Design requires modification to consider 2 story defensive positions (8 meters high)

TOP VIEW LEVEL 1 + LEVEL 2

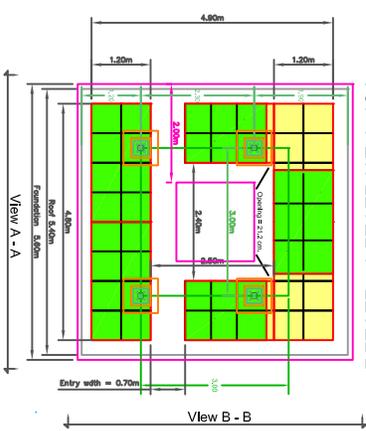
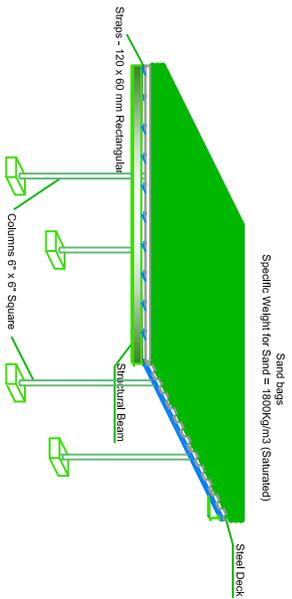
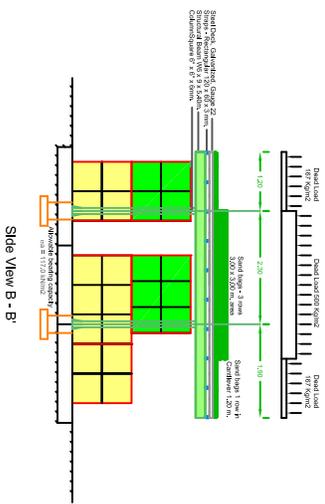
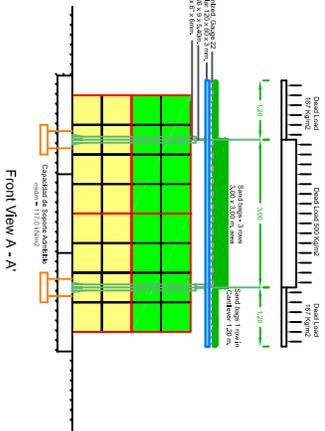
Foundation and structural designs requires modification to consider 2 story defensive positions. Intermediate floor deck between 1st and 2nd story, top roof (total height 8 meters), sand bags, armor guns (approx 120 lbs), munitions (approx 50 lbs), and 6 soldiers. Contractor shall submit certified design to COR prior order material and start construction. Design shall be certify by structural engineer.
